XTO Permian Operating LLC Respectfully requests approval to perform the bradenhead squeeze in the intermediate 2 casing after fracing operations as per Figure D in the R-111-Q document. I have attached updated design in the email. There are no changes to proposed casing points & grades and cement program top in the approved APDs

R-111-Q: Potential Potash Pivot Well Design

Operator: XTO PERMIAN OPERATING LLC. 6401 HOLIDAY HILL ROAD MIDLAND, TX 79707	OGRID: 373075
	Action Number: 419278
	Action Type: [C-103] NOI Change of Plans (C-103A)

[Figure D] 4 String – Uncemented annulus between 1st and 2nd intermediate casing strings

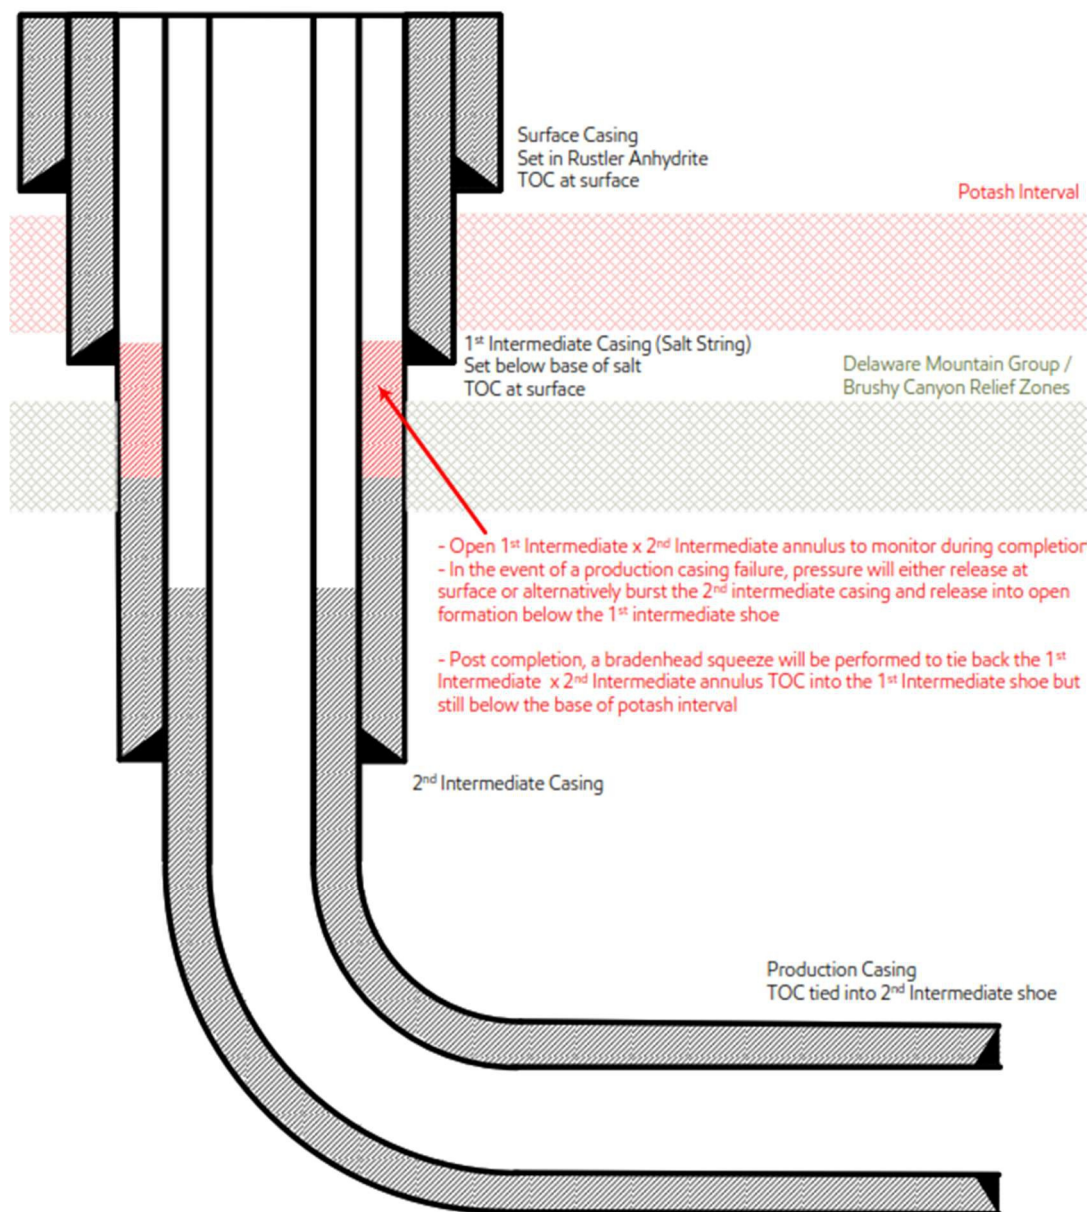
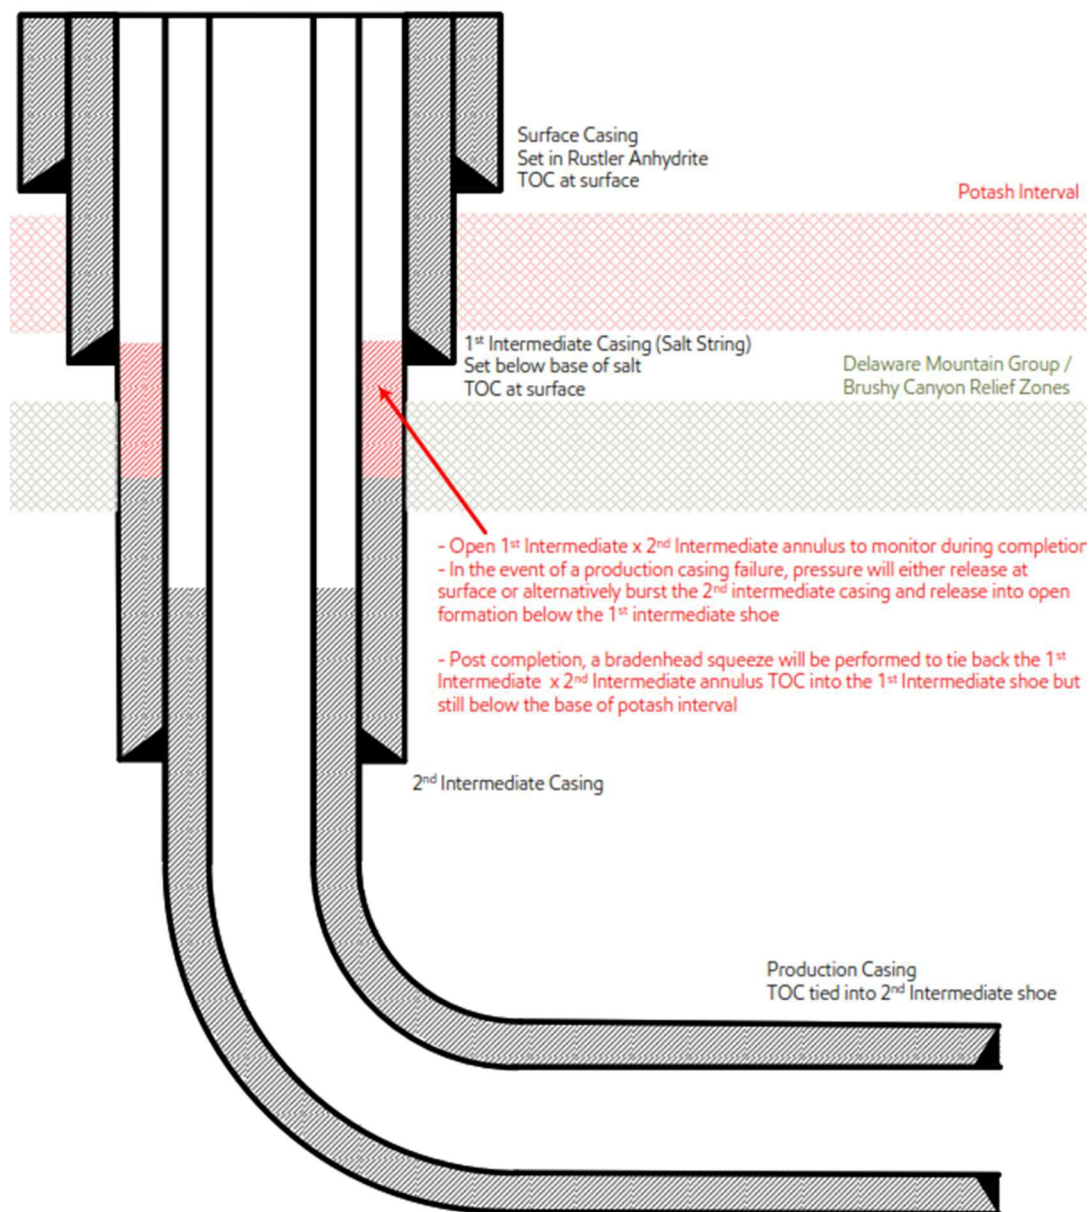
- 1) Alignment with KPLA requirements per schematic above, leaving open annulus open for pressure monitoring during frac and utilizing new casing that meets API standards.
- 2) Contingency plans in place to divert fluids away from salt interval in event of production casing failure.
- 3) Bradenhead squeeze to be completed within 180 days to tieback TOC to salt string at least 500ft but with top below Marker Bed 126.
- 4) Production cement to be tied back no less than 500ft inside previous casing shoe.

Created By	Condition	Condition Date
ward.rikala	Any previous COA's not addressed within the updated COA's still apply.	1/10/2025
ward.rikala	This well is within the R-111-Q potash area. The 1st intermediate casing string shall be cemented back to surface. Immediately following the cementing of the 2nd intermediate casing string, a CBL is required to document where the TOC is located. Immediately following the cementing of the production casing string, a CBL is required to document where the TOC is located. The bradenhead cement squeeze post frac shall provide a minimum of 500' of tie back into the 1st intermediate casing string.	1/10/2025

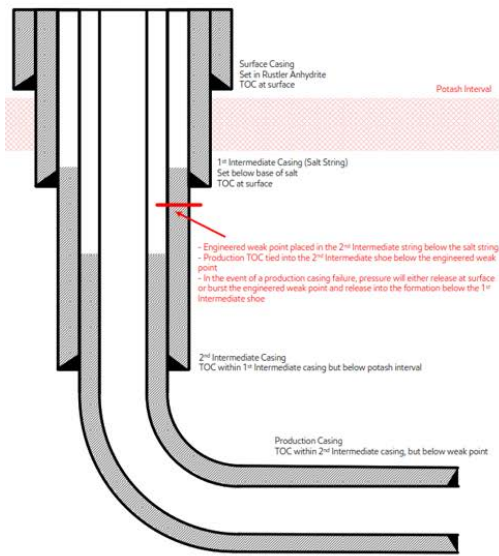
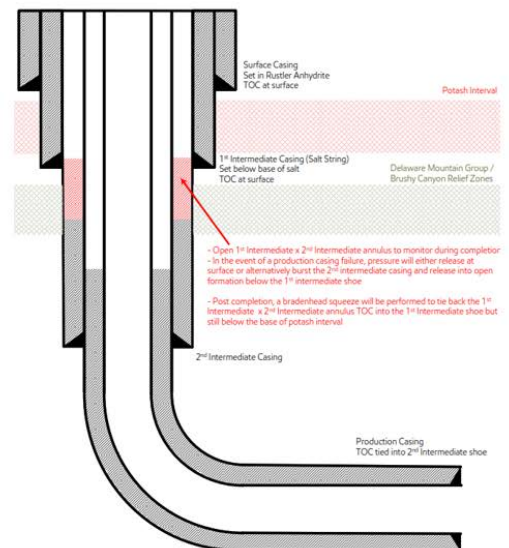
CURRENT 4-string design

POTENTIAL pivot 4-string design
